7080 Yonge Limited SFRA Deputation

Vaughan Council Committee of the Whole (Public Meeting), item 5

January 19, 2021

Jordan Max, SFRA President

Mislocation of 45 Degree Angular Plane

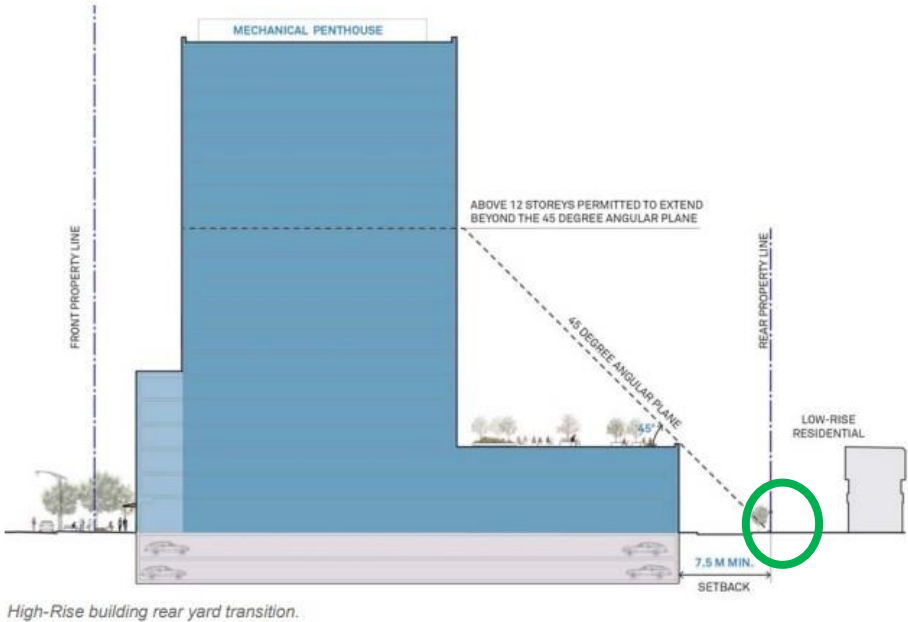
VUDG Standard 5.3.6

Chestnut Hill Illustration

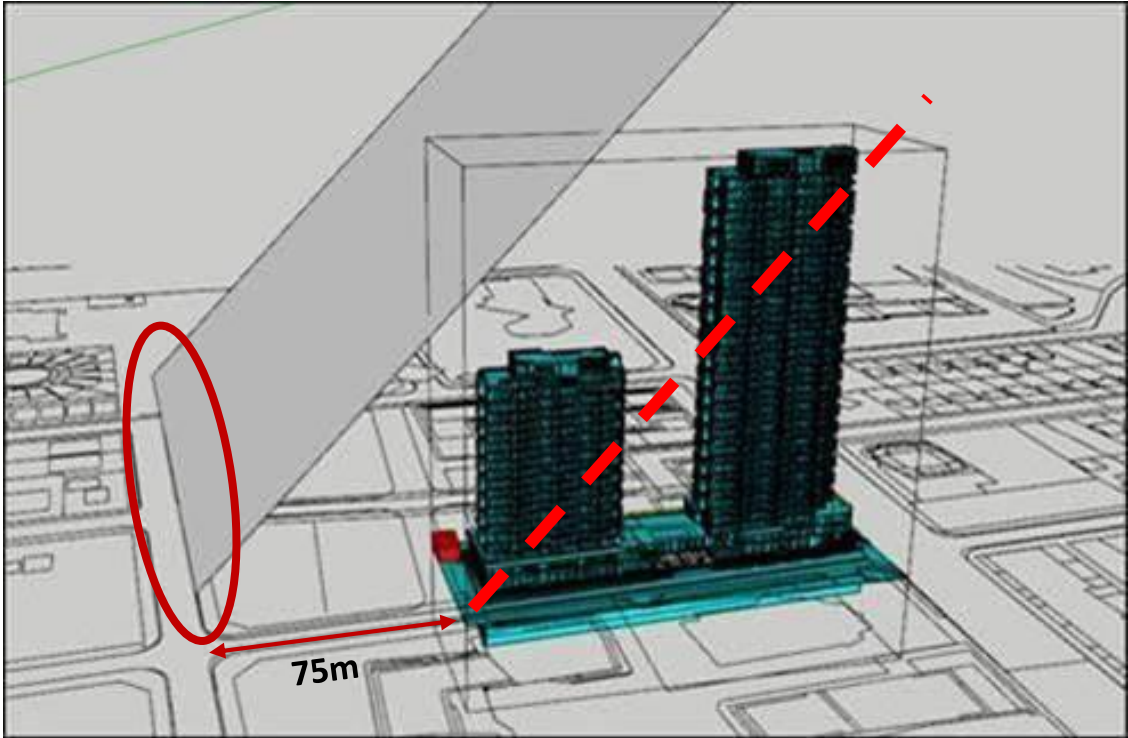
Encroachment on Public Green Space

Excessive Population Density

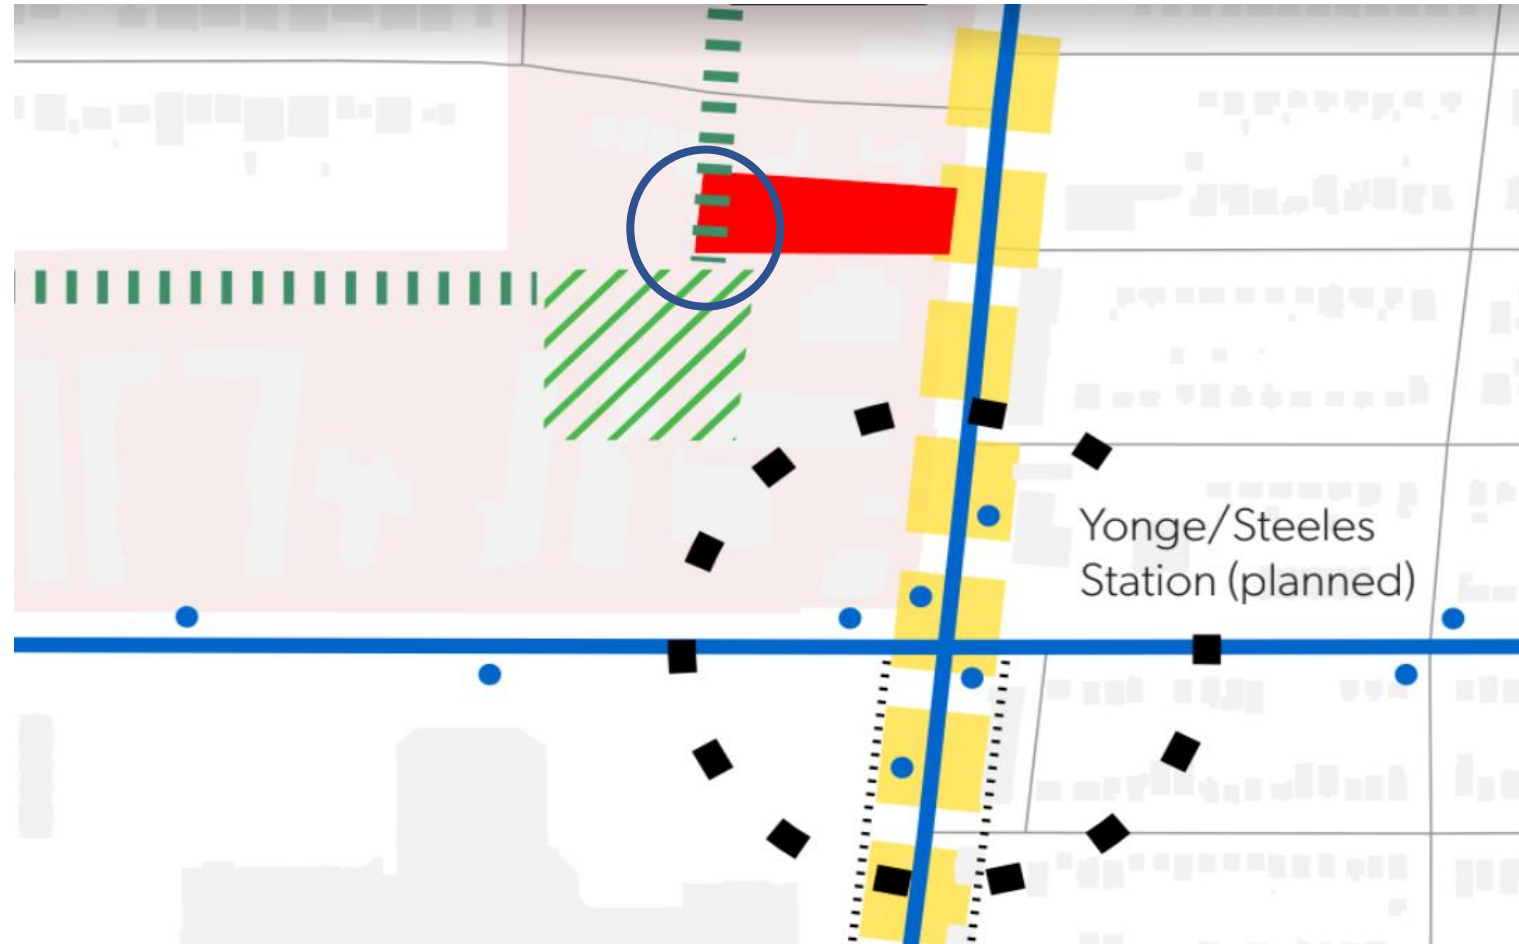
- $652 \text{ units} \times 1.5 \text{ ppu} = 978$
- $978 \text{ persons} / 0.5 \text{ ha} = 1,956 \text{ persons/hectare}$
- **SECOND MOST DENSE SITE ANYWHERE IN THE GTA!**
